**CITY OF CARLTON
PLANNING COMMISSION AGENDA
MONDAY, JANUARY 8, 2024, 6:00 P.M.
VIA ZOOM AND 945 WEST GRANT STREET**

A. Subdivision file #SUB 2023-02; 751 South 2nd Street – continued

To: Members of the Planning Commission
From: Scott Whyte, Contract Planner for the City of Carlton
Subject: Continued Public Hearing for 2nd Street Preliminary Subdivision, SUB 2023-02
Date: December 29, 2023, for the January 8, 2024, meeting

**CONCEPTUAL NEIGHBORHOOD CIRCULATION PLAN
 S 2ND STREET SUBDIVISION
 OPTION 3
 CARLTON, OREGON**

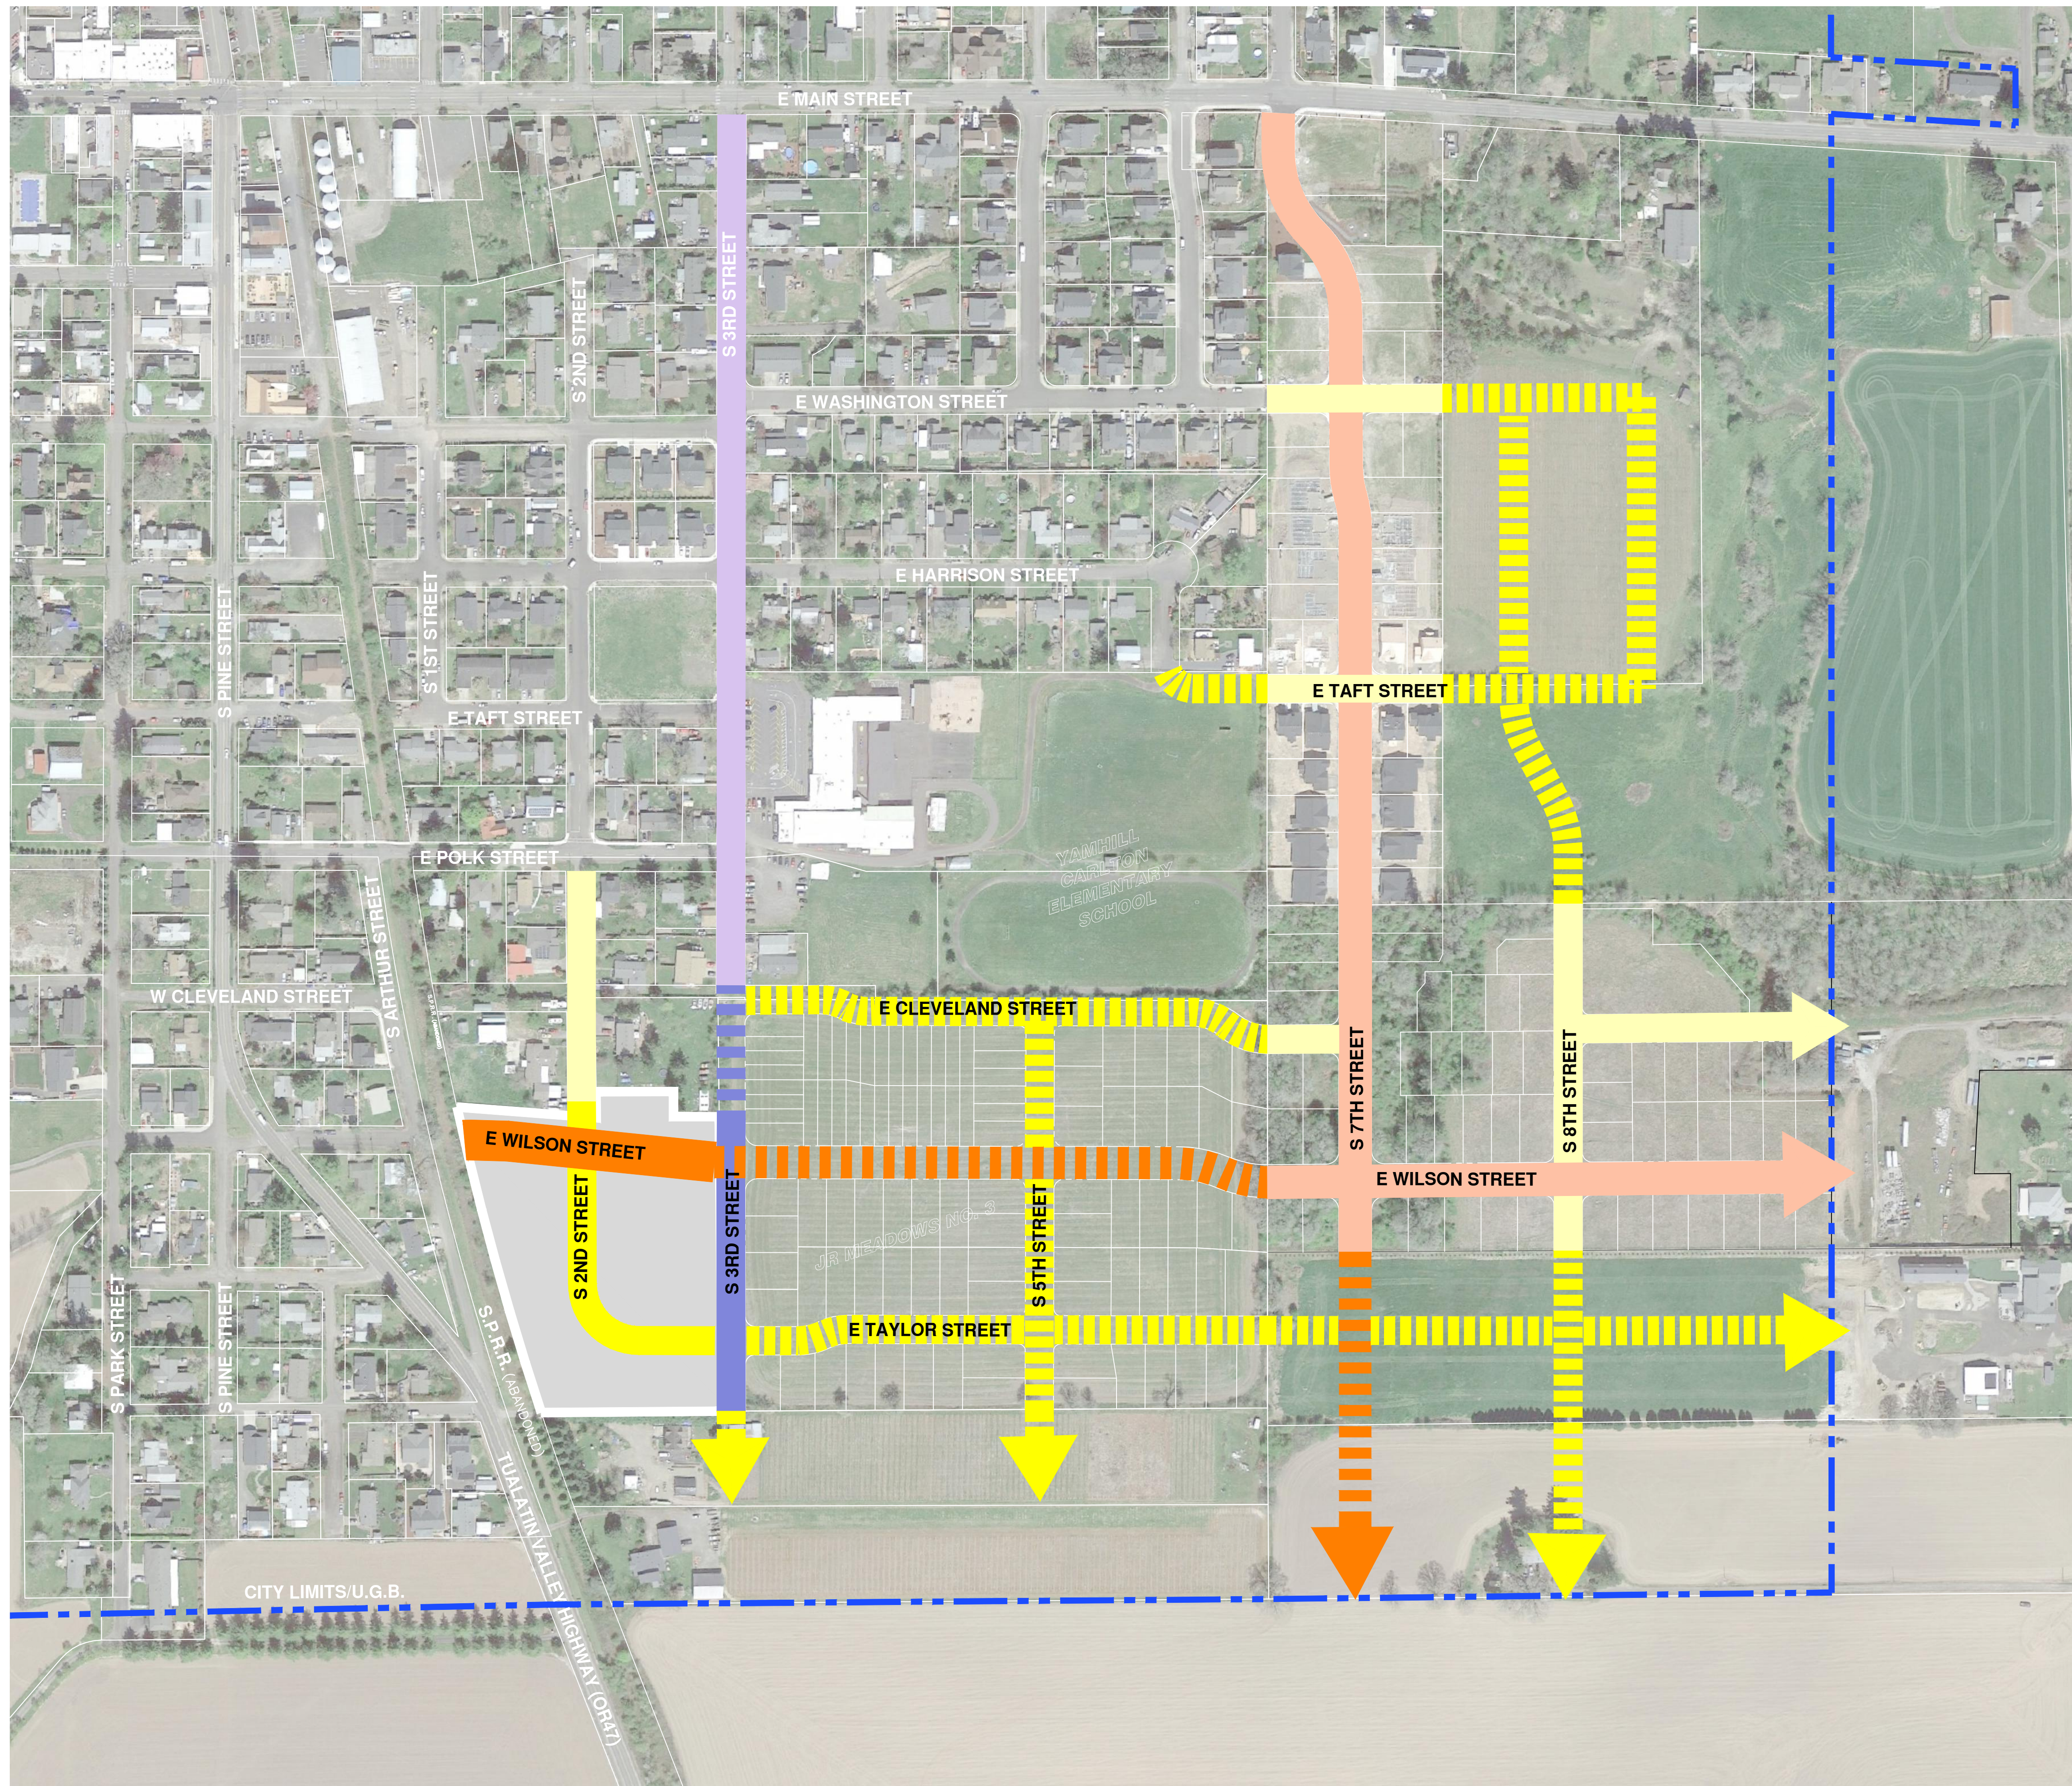
Supplemental Findings – Staff Review of **Exhibit B-9 - Alignment Option 3**: Exhibit B-9 is a full set of plans for Option 3. In review of Alignment Option 3 (no street extension to the western boundary for alignment with W. Taylor Street) staff finds the standard in D of 17.64.030 (Future Extension of Streets) to remain applicable and is not met. The staff memorandum dated December 4, 2023, contains findings in response to Option 3 and staff incorporate hereto.

Option 3 - Staff Findings: Staff observes how the traffic memo does not address the TSP connection of Taylor Street at Highway 47. Staff finds the standard in D of 17.64.030 (Future Extension of Streets) to remain applicable and is not met. The staff memorandum dated December 4, 2023, contains findings in response to Option 3 and staff incorporate hereto.

As noted in the staff memorandum of December 4, if no stub of Taylor Street is provided to the west (as depicted in Option 3) staff finds a TSP map amendment application to be warranted. As previously mentioned, the intersection at Taylor / Highway 47 (and other city intersections) will be studied at a network level in 2024 as part of the TSP update. A system / network level evaluation of the Future Street Plan is expected as part of the TPS update.

Staff further conclude Alignment Option 3 (Exhibit B-9) does not fully extend E. Taylor Street to a point that enables future connection consistent with the Carlton TSP Future Street Plan and therefore does not meet the standard in D of CDC 17.64.030. For reasons identified in this memorandum and past reports, staff cannot support Option 3 and therefore does not recommend approval of this option. Furthermore, staff conclude that Option 3 warrants a plan map amendment.

**CONCEPTUAL NEIGHBORHOOD CIRCULATION PLAN
 S 2ND STREET SUBDIVISION
 OPTION 4
 CARLTON, OREGON**

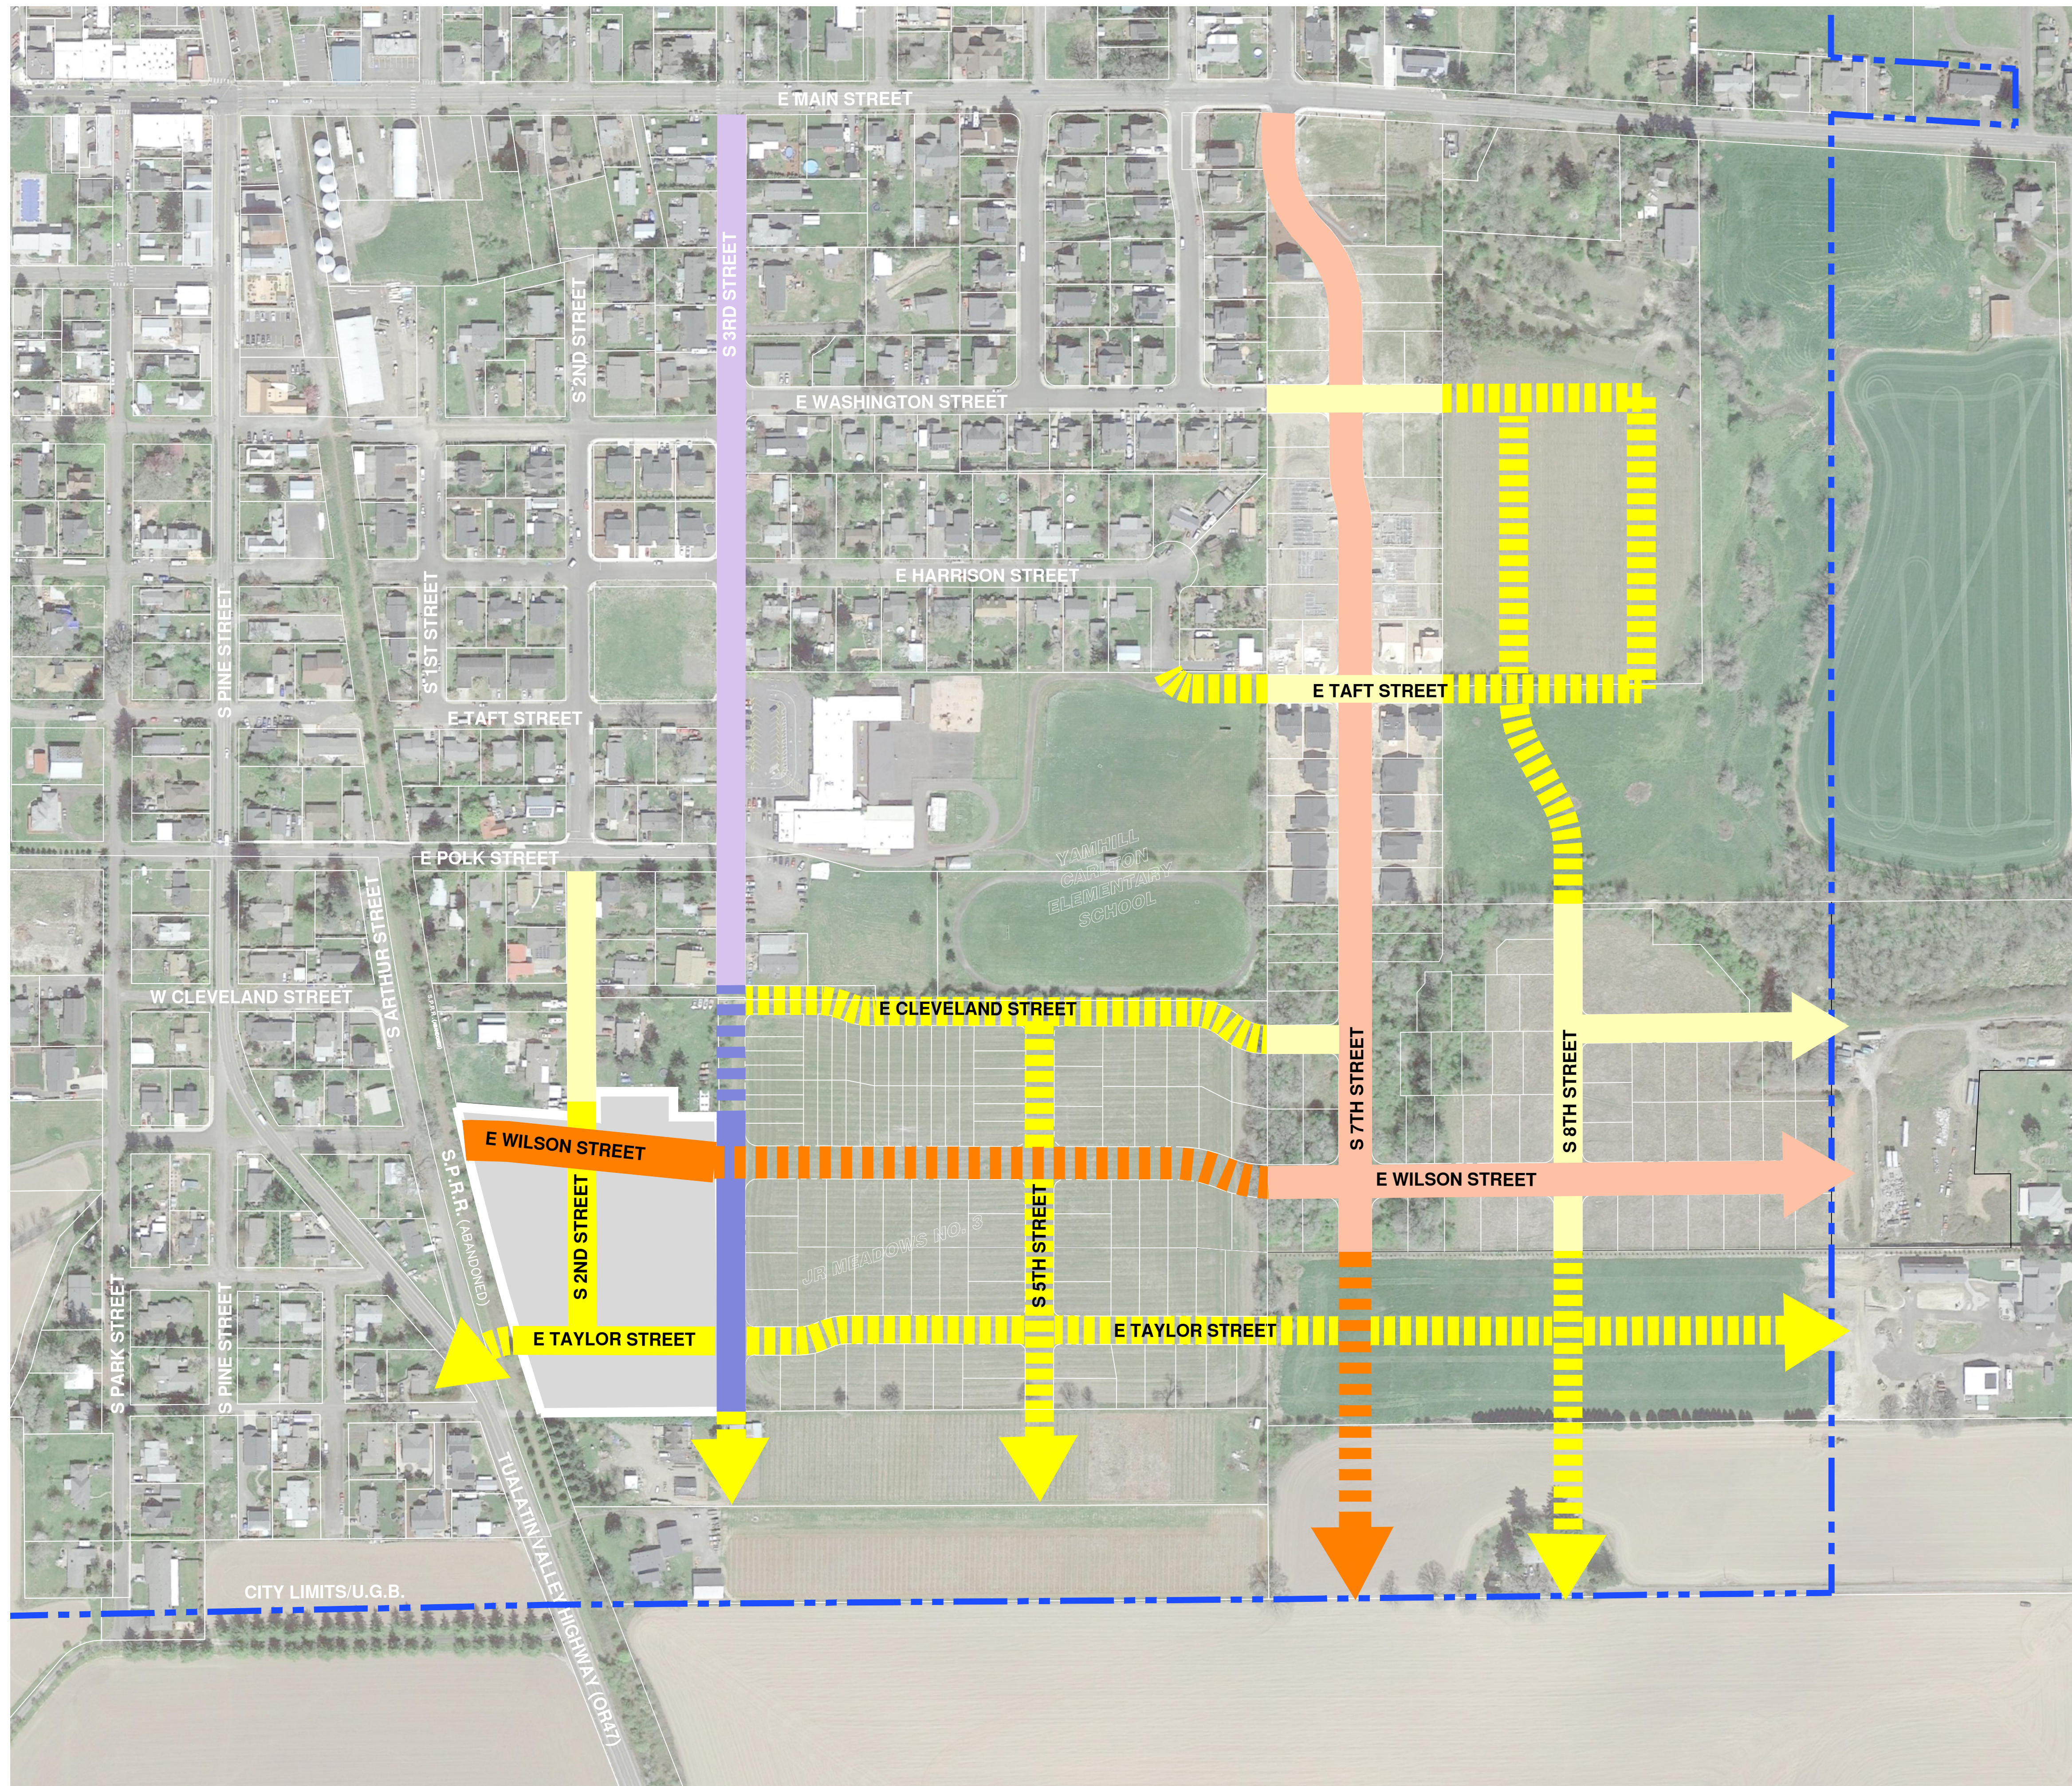
Supplemental Findings – Staff Review of **Exhibit B-10 - Alignment Option 4**: Exhibit B-10 is a full set of plans for Option 4. Staff observe Option 4 to be the applicant’s previous subdivision proposal (subject to hearing consideration on November 13). The staff report dated November 6, 2023, contains findings in response to Option 4; staff incorporate hereto. In part, the staff report of November 6 explains how the future connections (referring to concepts shown to Hwy. 47) are difficult for ODOT approve. This is based on feedback received from Casey Knecht P.E. of ODOT Region 2 (his full comments provided in the November 6 staff report).

Option 4 - Staff Findings: Staff observes how the traffic memo does not address feedback received from Casey Knecht P.E. of ODOT Region 2. Staff finds the standard in C of 17.64.030 (Alignment) to remain applicable and is not met. The staff report dated November 6, 2023, contains findings in response to Option 4 and staff incorporate hereto.

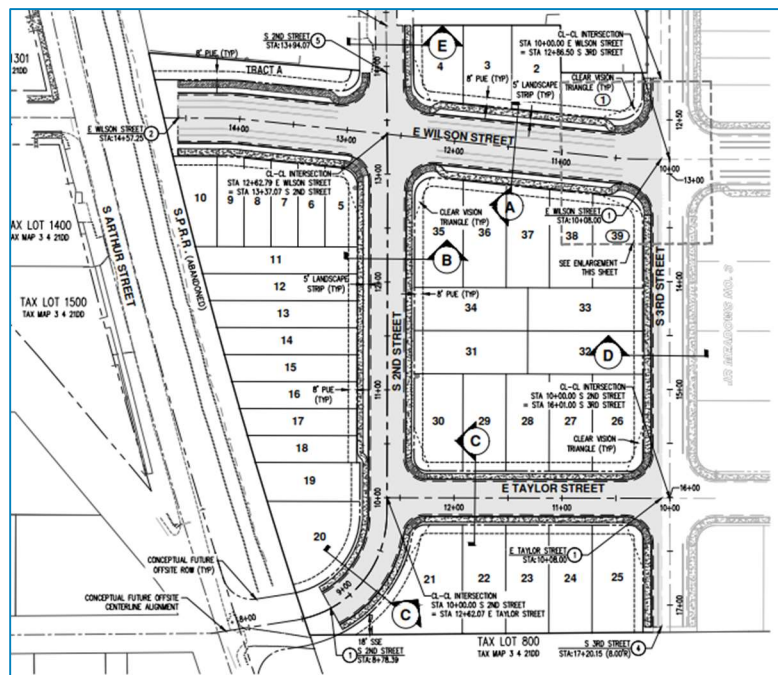
1. The skew angle of the eventual intersection with the highway does not meet ODOT or City of Carlton design standards.
2. This configuration requires the closure of S Arhtur Street at Highway 47.

Staff Finding: Staff observe how there is already an intersection in this location, and that the skew angle of a future connection to the highway on the east side can be addressed in design refinements. Staff also observe how the Carlton TSP shows the intersection of Taylor / Hwy. 47 to remain and for a street connection to be added (per Figure 5-4, Future Street Plan). Staff incorporate the findings above pertaining to the City Engineer's recommended modifications specific to Option 2. Staff also incorporate the findings above that explain how the intersection at Taylor / Highway 47 (and other city intersections) will be studied at a network level in 2024 as part of the TSP update. Staff also incorporate the above observation on how the applicant's traffic memo does not consider design alternatives or operational restrictions. In part, the staff memorandum of December 4 explained how the applicant's illustrations (related to vehicle queue) were unsubstantiated by data (i.e., queue methodology applied, circumstances, assumptions, and frequency of occurrence). The applicant recent traffic memo provides no further data in support of observations / claims of future potential conflicts.

Construction Traffic

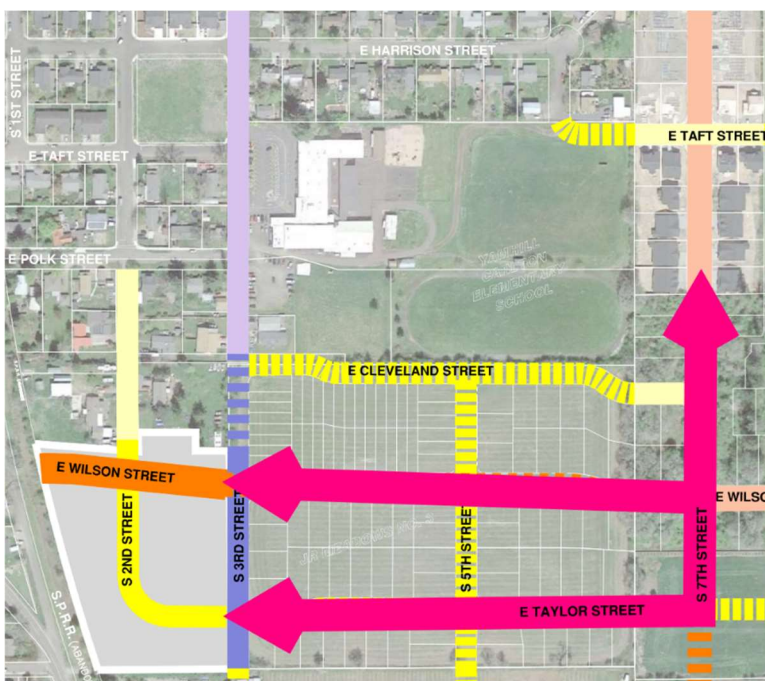
To alleviate traffic impacts to 2nd Street during construction, the applicant proposes to route all construction traffic to be routed through JR Meadows phases 1 through 3, via S 7th Street, E Wilson Street, and E Taylor Street. This routing is shown in the figure to the right.

Finally, staff observe how the applicant's traffic memo responds to concerns raised about construction traffic (via public testimony). To address traffic impacts to 2nd Street during construction, the applicant proposes to route all construction traffic through JR Meadows phases 1 through 3, via S. 7th Street, E. Wilson Street, and E. Taylor Street. This routing is shown to a figure in the traffic memo. Staff proposes a condition of approval pertaining to temporary signs for this purpose (type / location to be shown as part of construction plans).

- w. Detailed design drawings submitted to the city for street improvements are to show the type / location of temporary signs intended to route all construction traffic through JR Meadows phases 1 through 3, via S. 7th Street, E. Wilson Street, and E. Taylor Street.
